MARY E. RODMAN RECREATION CENTER RENOVATION

CONTRACT NO. 20814

ADDENDUM NO. 1

For: SPECIFICATIONS AND DRAWINGS

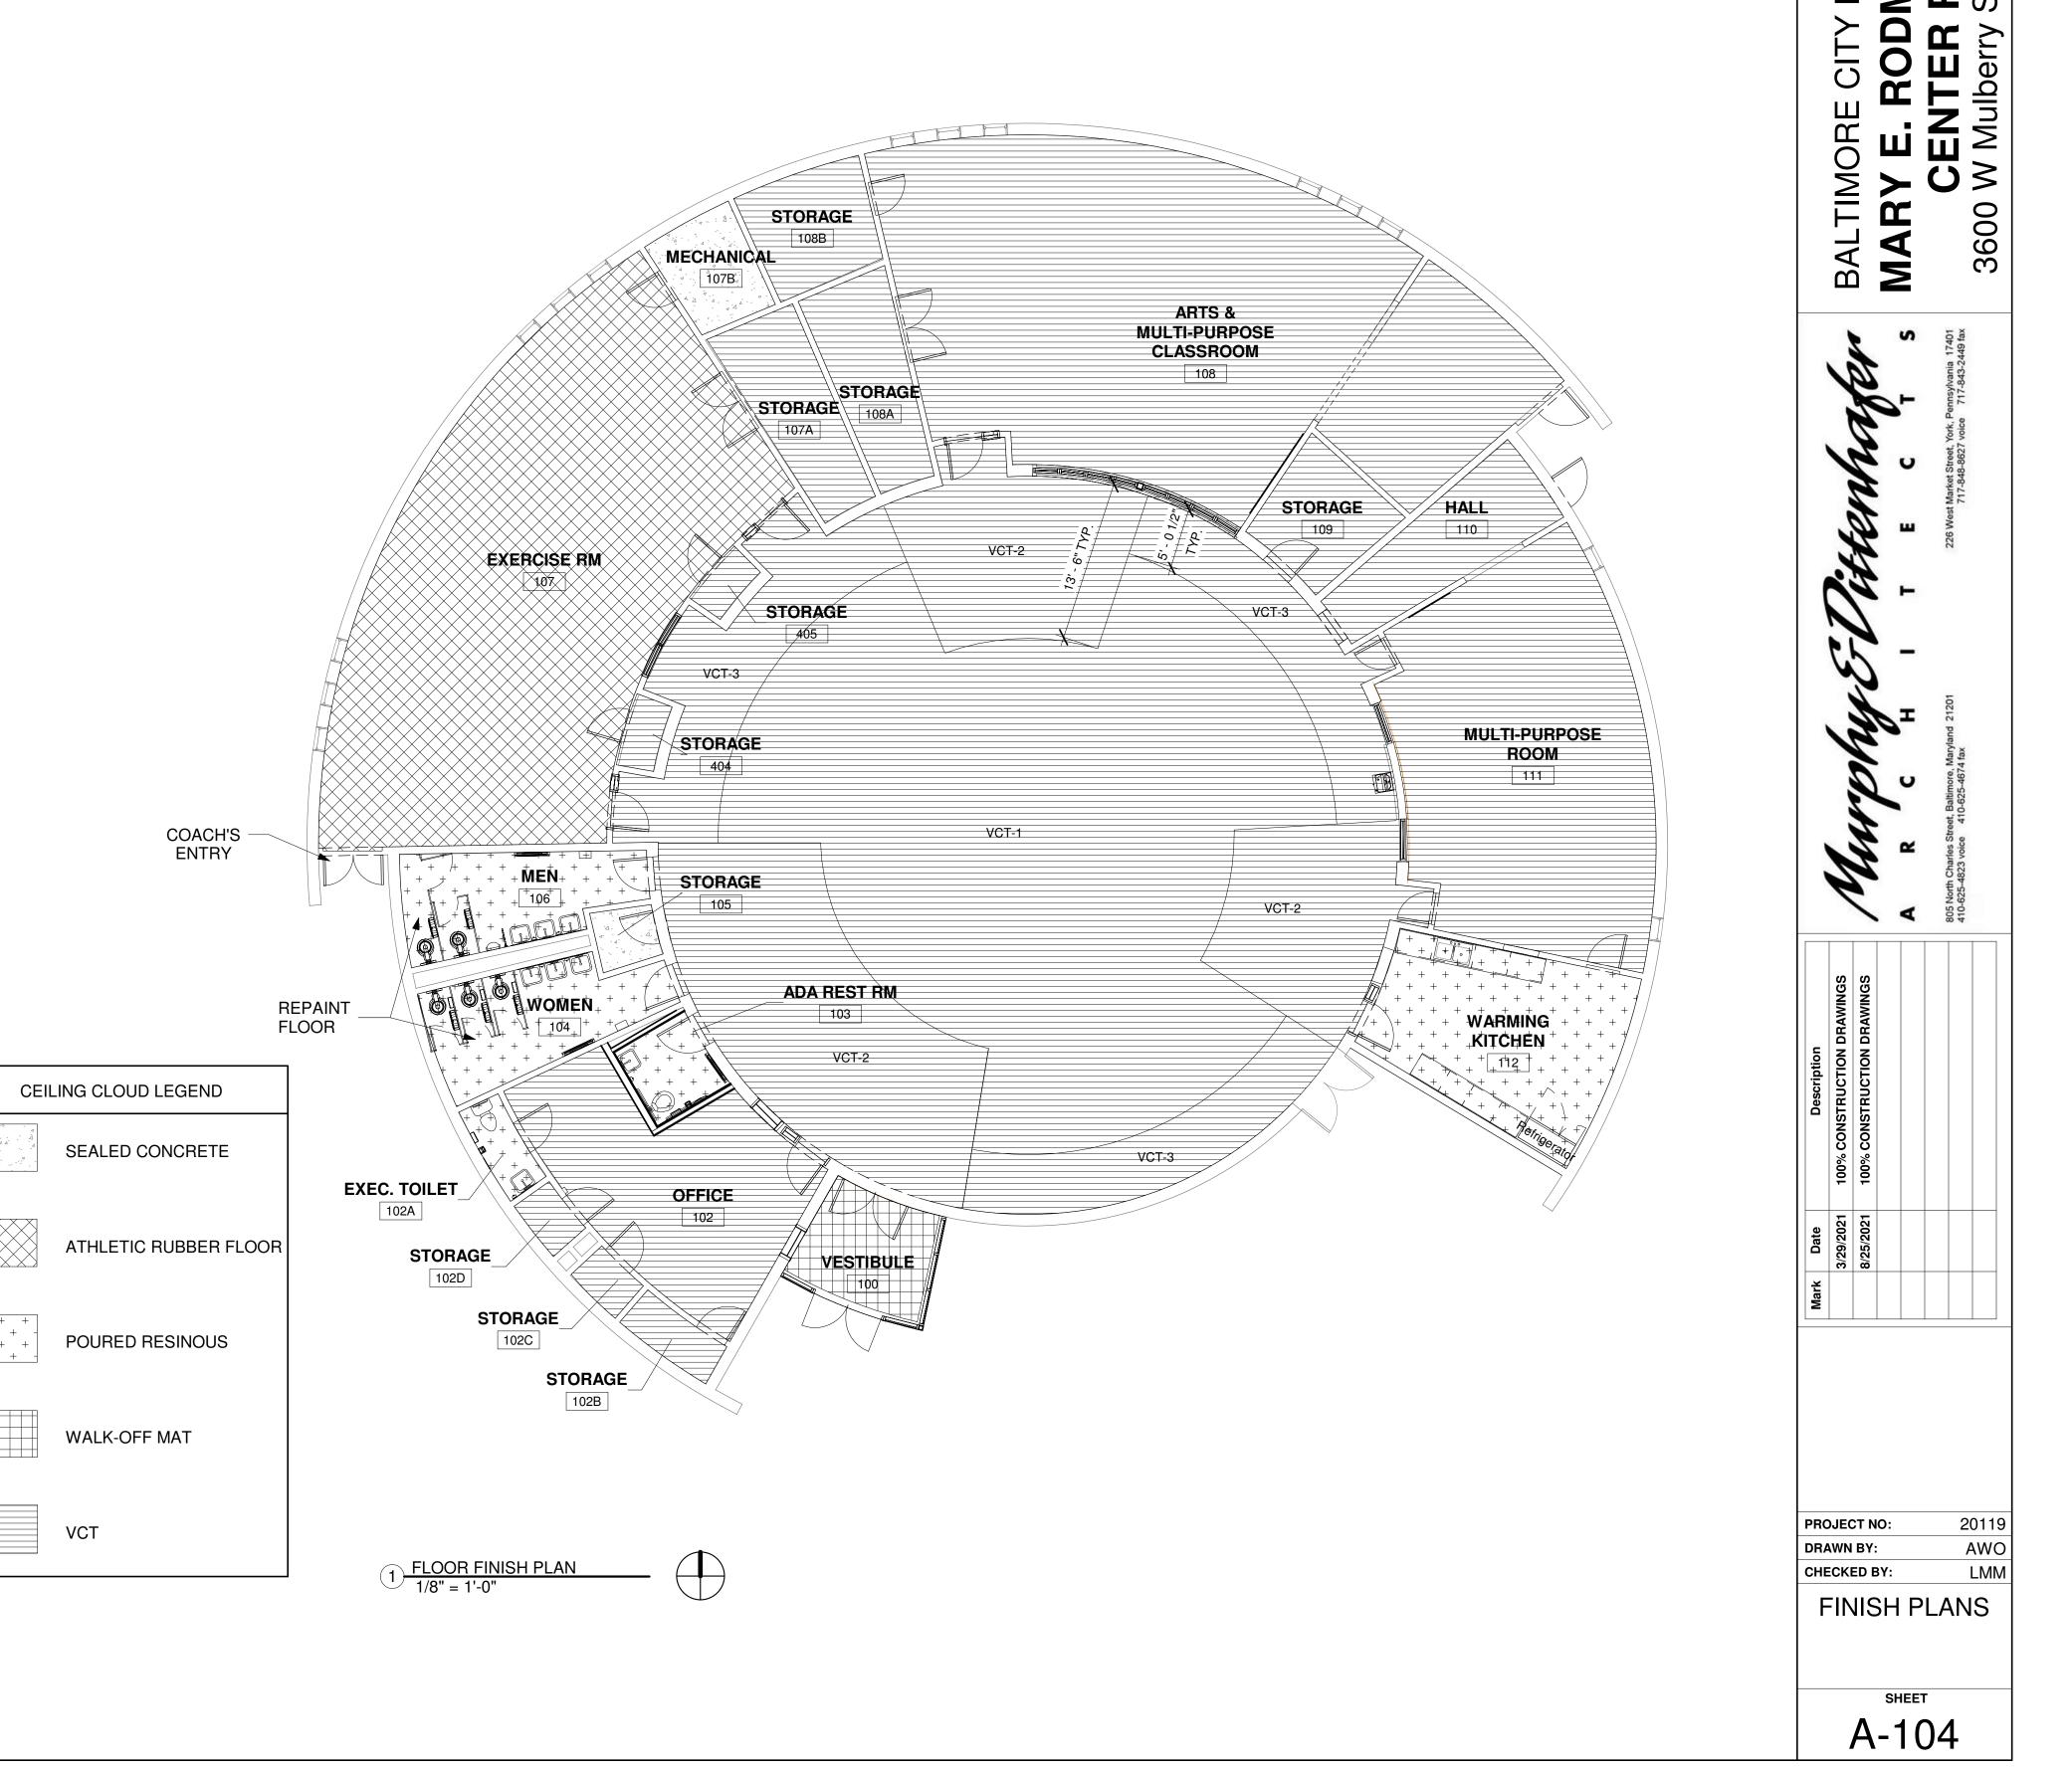
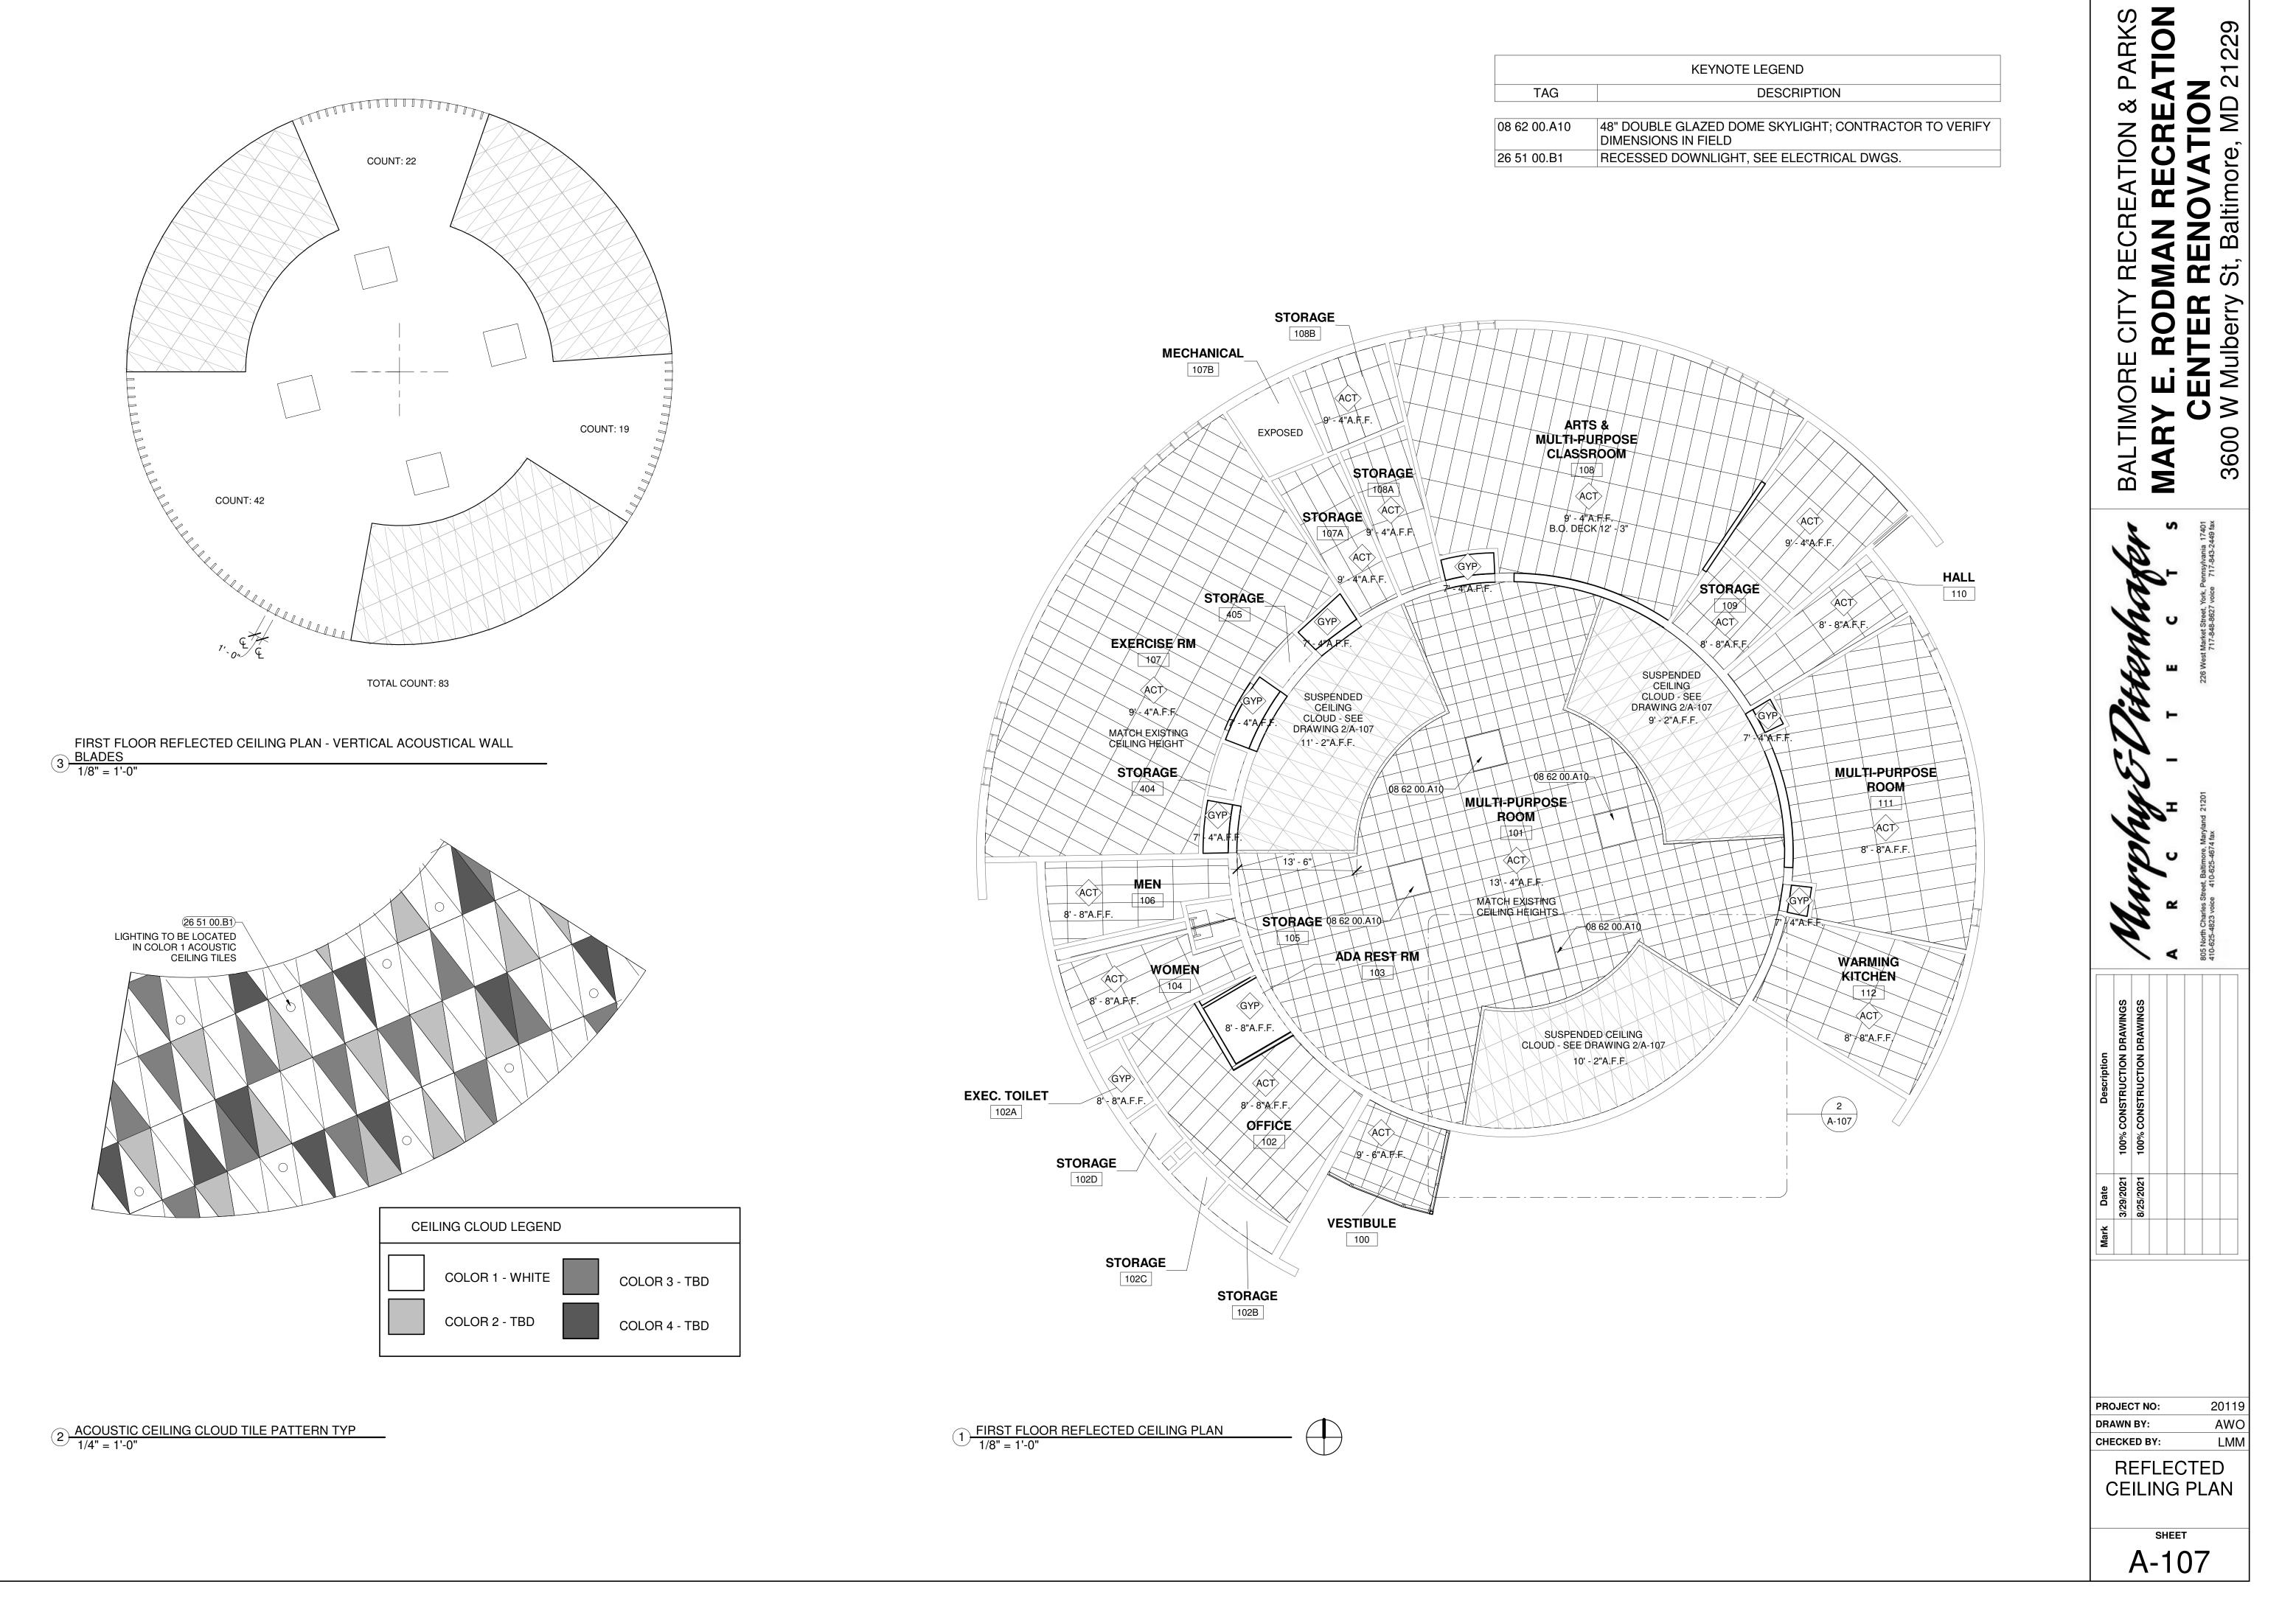
2.6 Sheet A-104, Finish Plans

- 1. Room Finish Schedule revised to Walk off mat, ACT-1 and PNT in the Vestibule.
- 2. Room Finish Schedule revised to GYP in 102A, and 103
- 3. Room Finish Schedule revised to remove Exec. Office Room 102 A
- 4. Room Finish Schedule revised to show rooms 404 and 405

4) Sheet A-101 shows Storage Room #404 and Storage Room #405, yet these rooms are not included on Sheet A-104's Room Finish Schedule. The Finish Plan on sheet A-104 D does show VCT flooring to be installed in Rooms #404 and #405. Can you confirm that the existing flooring is to be replaced with new VCT and that the ceiling finishes and wall paint is to be existing to remain for these two rooms?

7) There are several discrepancies between the Room Finish Schedule and the drawing's plans that need to be clarified. The Vestibule finish schedules states VCT floor finish and ACT-1 ceiling finish while 1/A-104 show walk-off mat flooring and 1/A-107 shows both gypsum board ceiling and ACT. The Finish schedule says that the Vestibule walls are ETR, yet the proposed new CMU should likely have a painted finish and the existing exterior walls to be butted and becoming interior walls will likewise require new paint. For both rooms #102A Executive Toilet and 103 ADA Restroom, the finish schedules states ACT-1 ceiling finish, but 1/A-107 shows gypsum board ceiling. Please clarify the desired finish for each of these discrepancies.

Answer: Storage Rooms 404 and 405 have been added to the finish schedule. These rooms are to receive new VCT flooring. Confirmed: ceiling finish and wall paint is existing to remain for these two rooms.

Answer: Vestibule floor to be walk off matt, Vestibule ceiling to be 2x2 ACT, Vestibule interior walls of new CMU to be painted. Room #102A ceiling to be GWB, Room #103 ADA Restroom to be GWB
